AGENDA
Veneta Planning Commission
TUESDAY – October 6, 2015 – 6:30 p.m.
Veneta City Hall

**VENETA PLANNING COMMISSION'S
STAFF REPORT**

Veneta Veterinary Hospital – Site Plan Review

**Veneta Veterinary Hospital, Site Plan Review (SR-3-15),
Assessor's Map and Tax Lot No. 17-05-31-20-01300**

1 SITE PLAN
C1.1

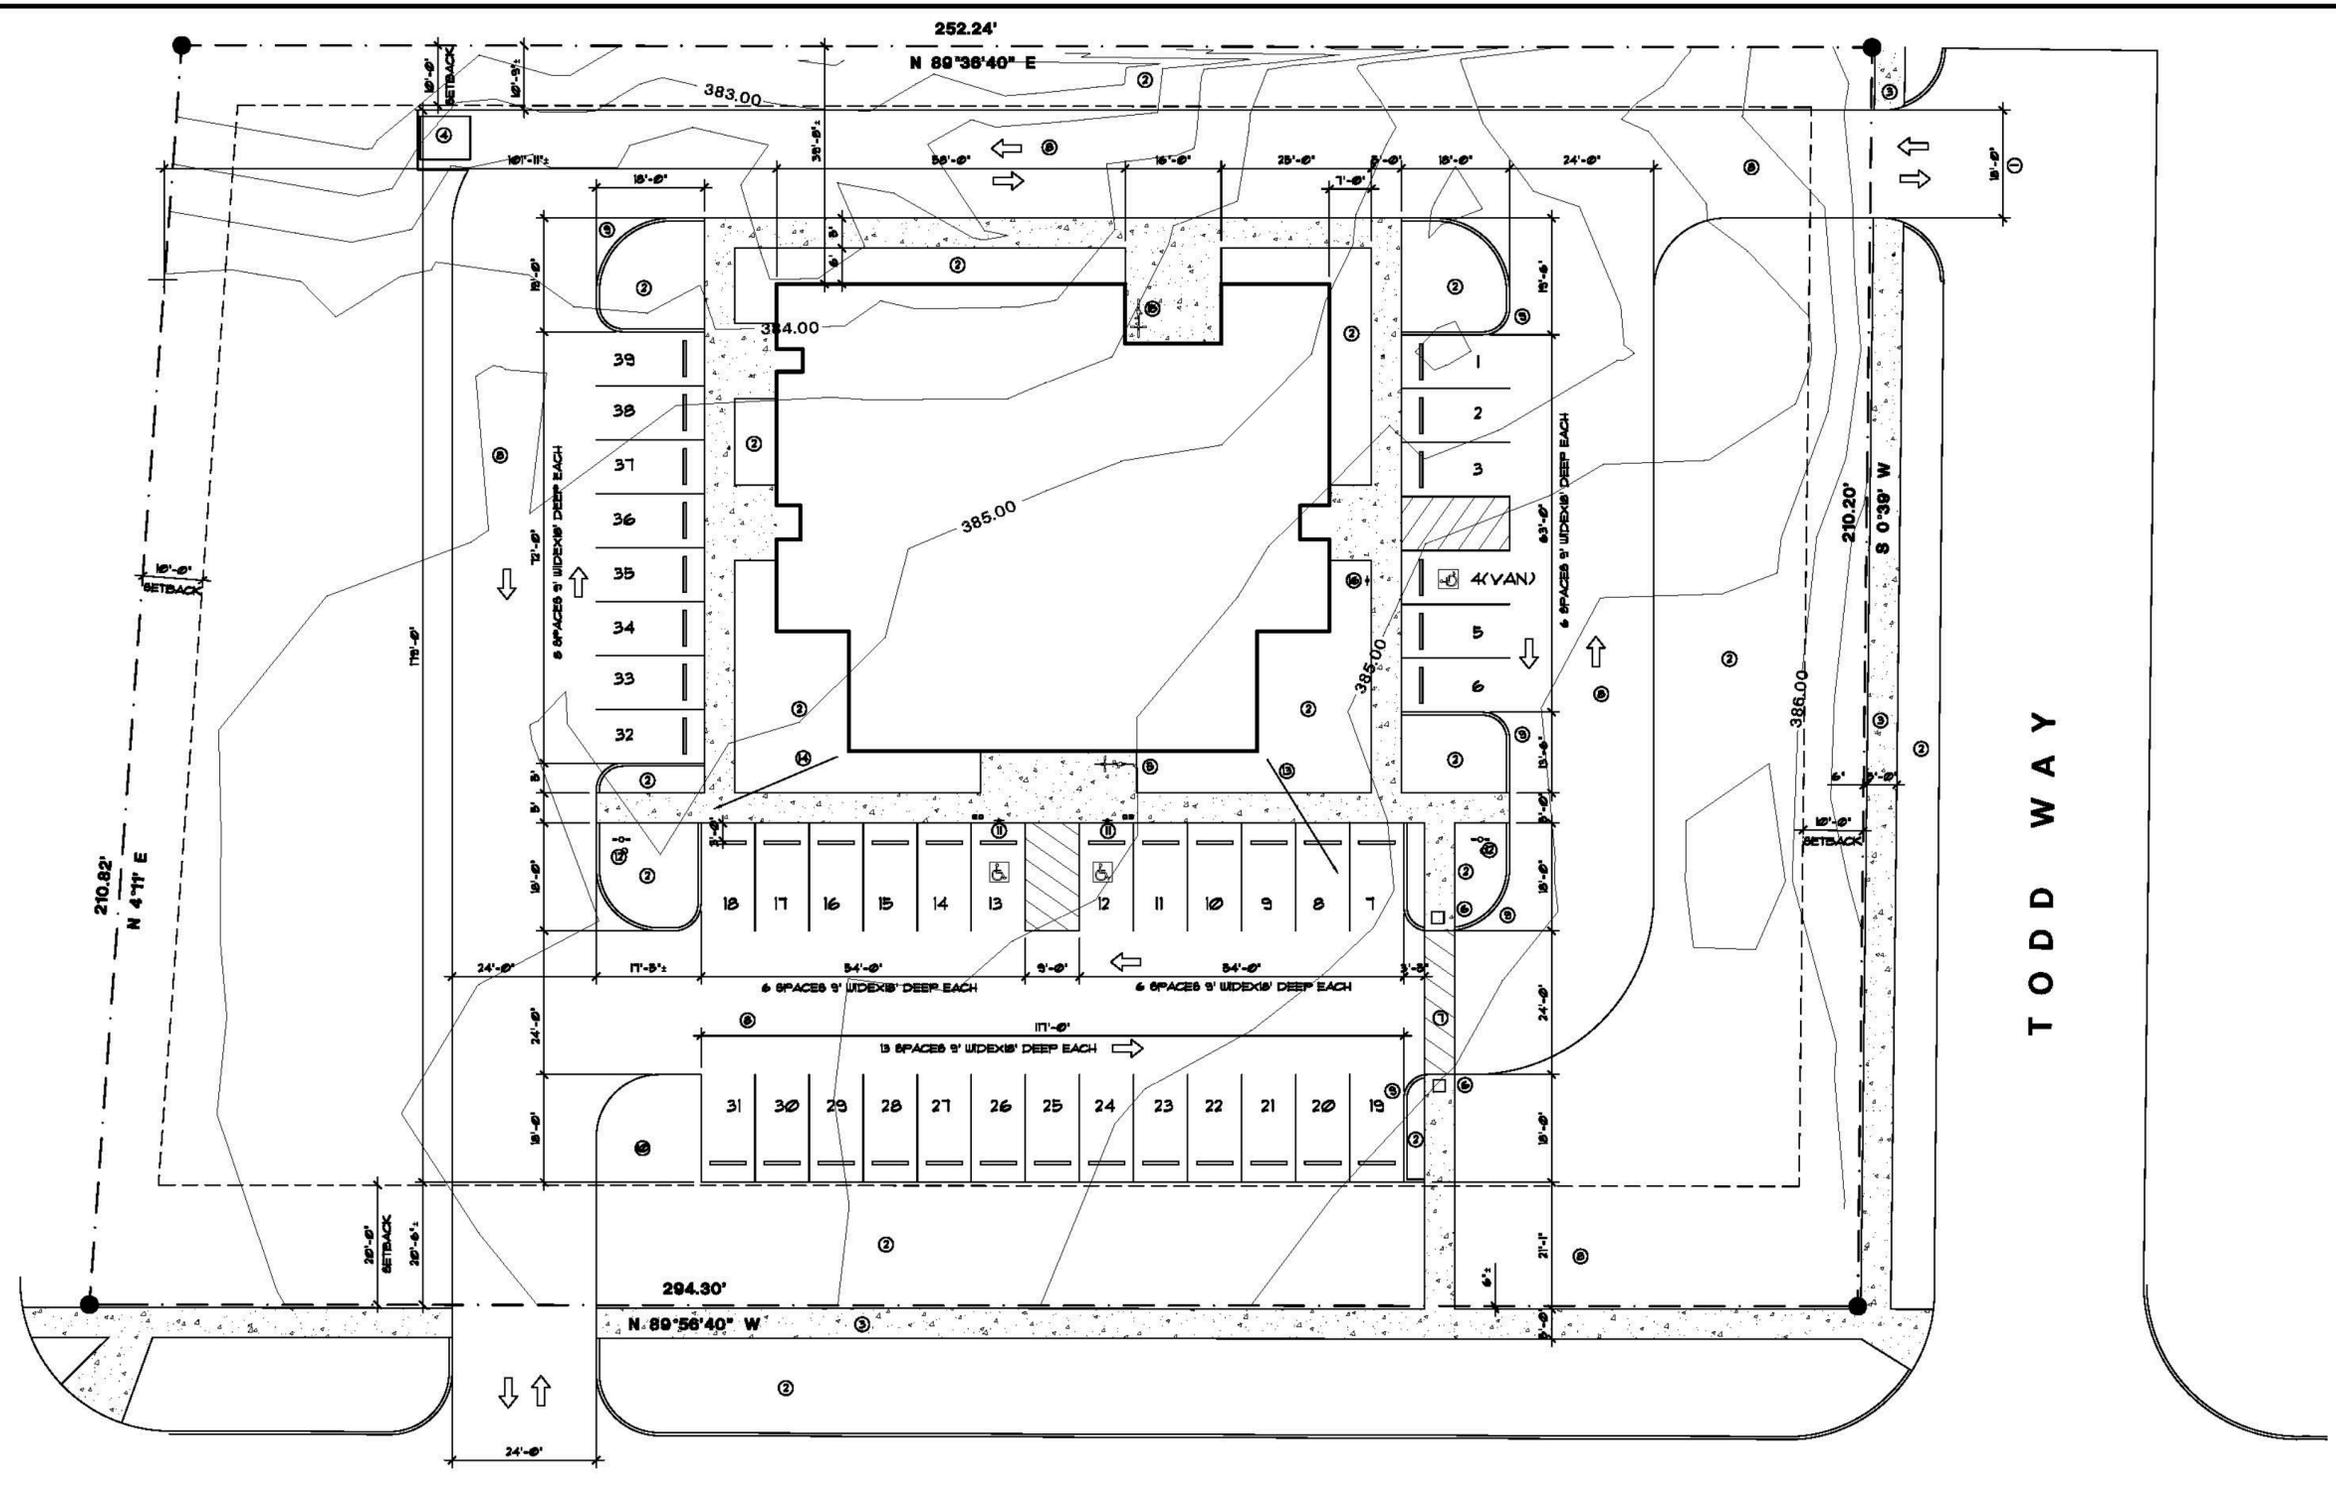
The applicant is proposing parking lot areas to the side and front of the building. Veneta Land Development Ordinance No. 493, Section 5.20(3)(c) requires parking for new commercial to be located at the side or rear of the building. A condition of approval is recommended to require the applicant to submit and receive approval of a revised site plan with all proposed parking lot areas to be located to the side or rear of the building in accordance with Veneta Land Development Ordinance No. 493, Section 5.20(3)(c)- Off Street Parking Standards.

There is an existing vehicle access on the south side of Jeans Road near the proposed west access and it is unclear if the accesses will align. Aligned accesses provide for safer turn movements and assist in aligning right of way. A condition of approval is recommended for the applicant to illustrate the western access along Jeans Road at Bi-Mart and align the proposed access off of Jeans Road with the existing access on the south side.

near the proposed west access. It is unclear if the accesses will align. Aligned accesses provide for safer turn movements and assist in assigning right-of-way. Prior to final site plan approval, the applicant shall illustrate Bi-Mart's western access. The western site access shall align with the existing access across the street per the City Engineer.

As conditioned, the proposal is consistent with this standard. The applicant is proposing the garbage collection area to be to the northwest corner of the building and within the parking lots as shown on the revised Site Plan (Sheet C1.1R). Prior to certificate of occupancy, garbage collection areas, service facilities and air conditioning facilities located outside of the building shall have sight-obscuring screening (must maintain at least 75 percent opaque when viewed from any angle or point 25-feet from fence) in accordance with Veneta Land Development Ordinance No. 493, Section 5.12(8) - Landscaping.

- 10) The applicant shall submit and receive approval of a revised Site Plan per Veneta Land Development Ordinance No. 493, Section 6.06(5), consistent with all conditions of approval including:

1 STORMWATER PLAN
C4.1

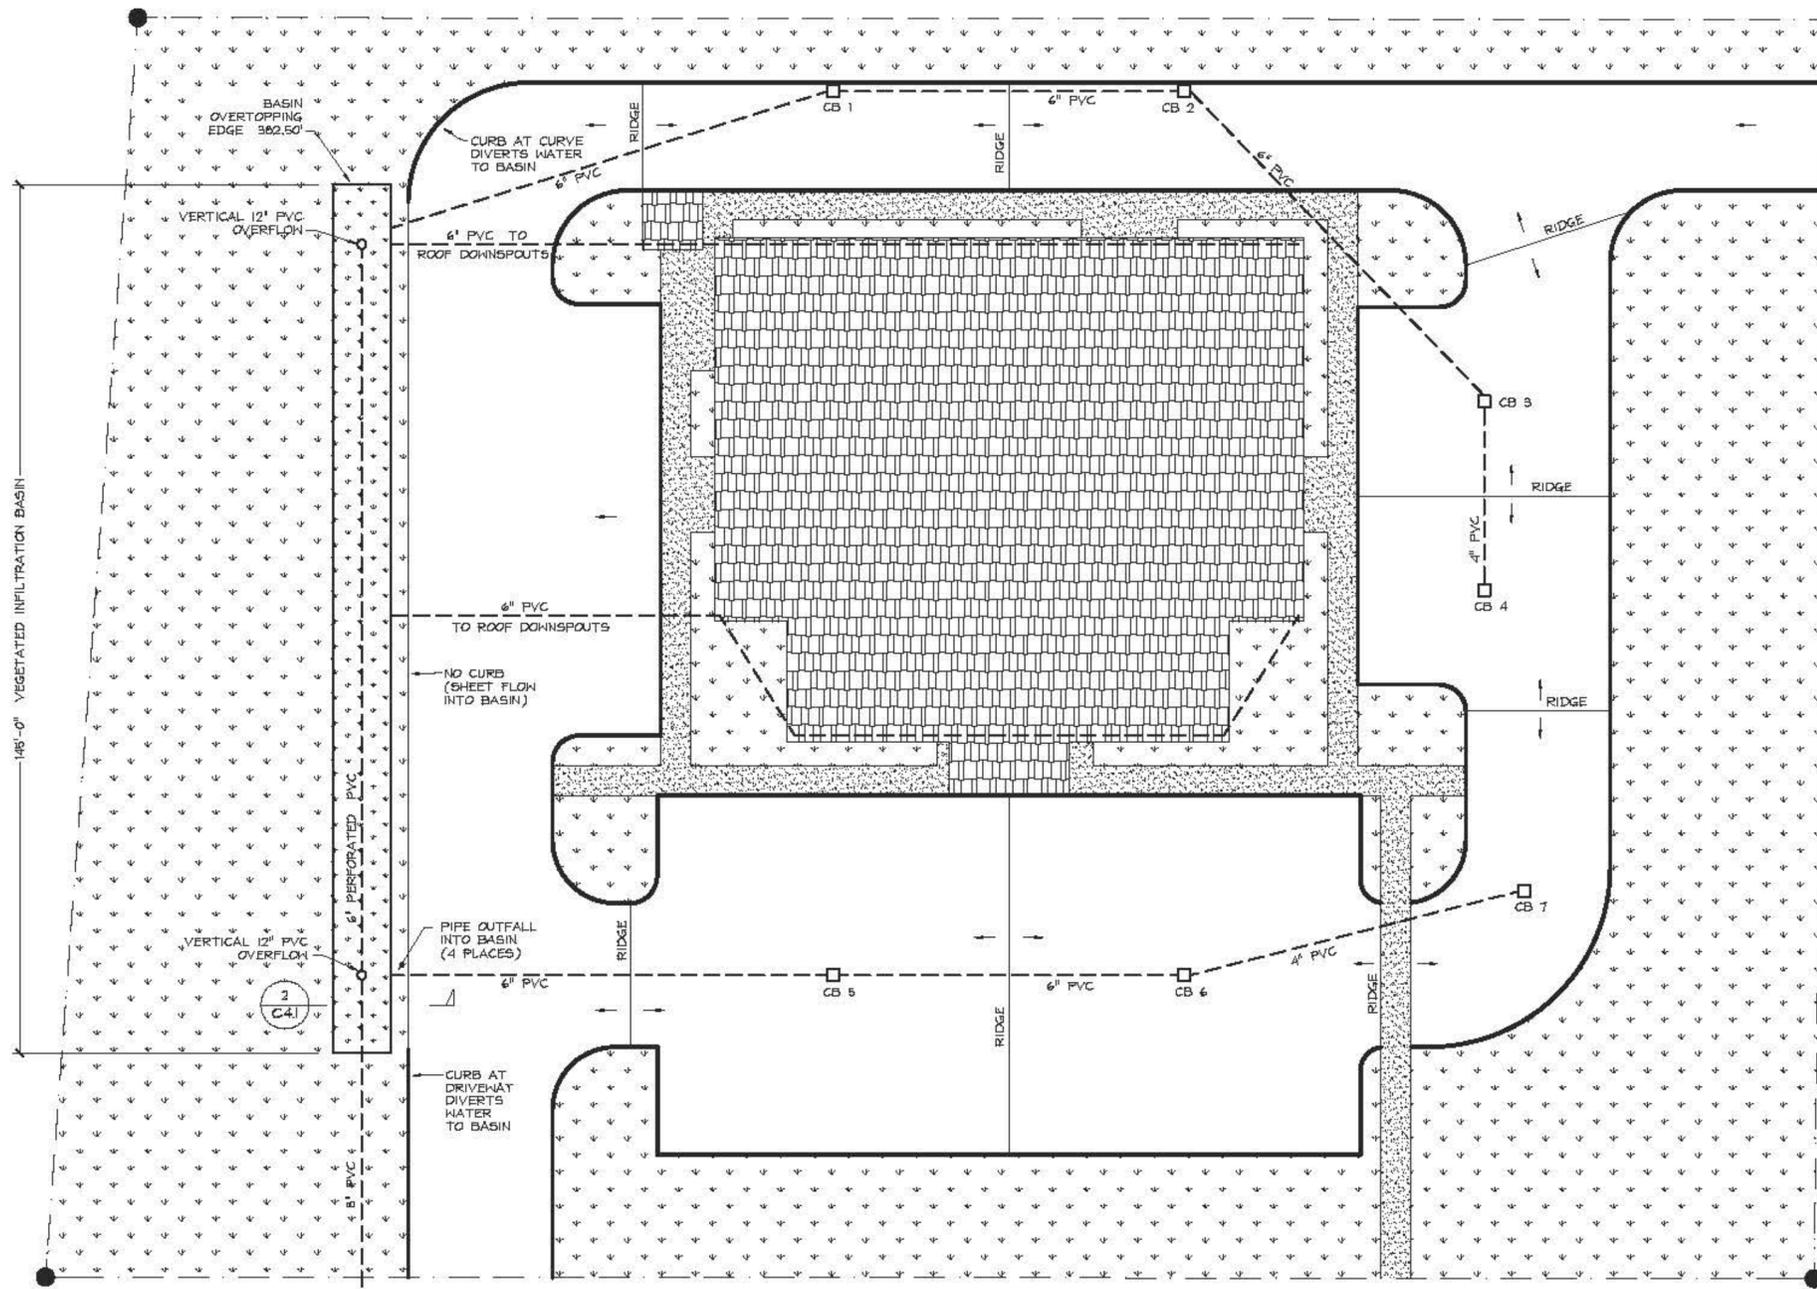
Prior to building permit issuance, stormwater calculations shall be submitted demonstrating the proposed stormwater system meets City of Veneta’s stormwater detention standard per the City Engineer. Prior to occupancy, the rain garden shall be planted in accordance with the adopted 2008 Portland Stormwater Management Manual (SWMM). City of Portland’s Stormwater Management Manual requirements and the City Engineer.

- 22) The applicant shall construct and plant the proposed stormwater detention and treatment area (proposed rain garden area) in accordance with the approved Final Site Plan and Final Landscape Plan and the adopted Portland Stormwater Management Manual, Revision #4, August 1, 2008 and accepted by the City Engineer per Veneta Land Development Ordinance No. 493, Section 5.12(10) and Section 5.16(1) – Stormwater Detention and Treatment.

2 EAST ELEVATION
A2.2

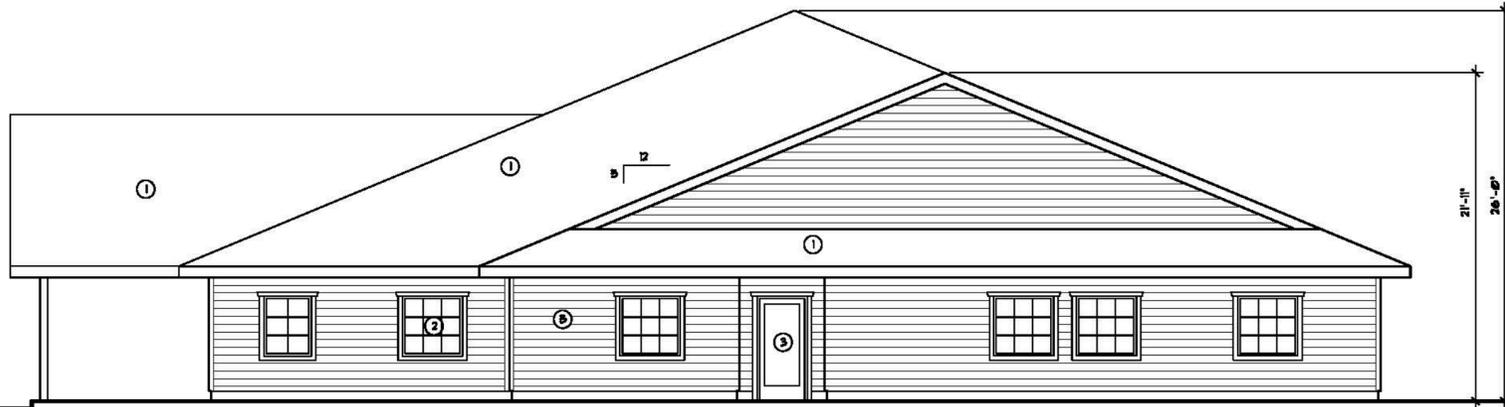
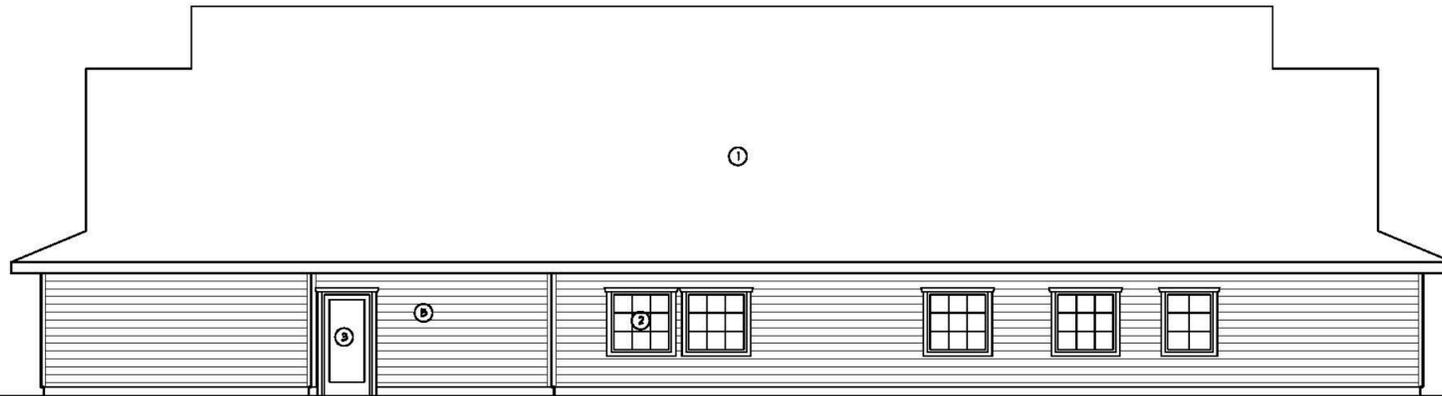
As conditioned, the proposal is consistent with this standard. the proposed floor plan and south elevation (Sheet A1.2 and A2.2) does not comply with Veneta Land Development Ordinance No. 493, Section 5.13(2)(i) which states, “All commercial building elevations in the RC, BC and CC zones facing a street, plaza, or other public or quasi-public space shall have openings (transparent windows, doors, balconies, etc.) covering not less than sixty percent (60%) of such elevations. Windows shall be sized/proportioned, shaped, placed/spaced, and trimmed consistent with the building’s overall architecture; and meet the intent, which is to provide visual interest from the outside of a building and natural surveillance from the inside, at a pedestrian level. Exception: Where a building faces more than one street, as on a corner, the above standard applies only on the elevation facing the primary street (i.e., Broadway, Territorial, or an internal driveway designed to substitute for a street). The standard is reduced by one-half for an elevation facing a secondary street.”

According to Sheet A1.2 and A2.2; sixty percent (60%) of the south elevation (which faces Jeans Road, a major collector) is equal to +/-441 square feet. The applicant is proposing +/-/-137.25 square feet of ‘openings’ (i.e. windows and doors) along the south elevation. Prior to final site plan approval, the applicant shall submit revised elevations plans depicting openings (transparent windows, doors, etc.) covering not less than sixty percent (60%) of such elevations in accordance with Veneta Land Development Ordinance No. 493, Section 4.06(8) – Building Orientation and Design.

The proposal is consistent with this standard. The submitted South Elevation and East Elevation (Sheet A2.2) which faces Jeans Road and Todd Way, depicts openings (transparent windows, doors, etc.) covering less than sixty percent (60%) of the elevation. Prior to construction, the applicant shall submit and receive approval of revised elevations plans (i.e. South Elevation and East Elevation) depicting openings (transparent windows, doors, etc.) covering not less than sixty percent (60%) of such elevations in accordance with Veneta Land Development Ordinance No. 493, Section 4.06(8) – Building Orientation and Design.

- 11) The applicant shall submit and receive approval of a revised Elevations Plans per Veneta Land Development Ordinance NO. 493, Section 6.06(5), consistent with all conditions of approval including:

- (a) Submit and receive approval of revised Elevations Plans (i.e. South Elevation and East Elevation) depicting openings (transparent windows, doors, etc.) covering not less than sixty percent (60%) of such elevations in accordance with Veneta Land Development Ordinance No. 493, Section 4.06(8) – Building Orientation and Design.
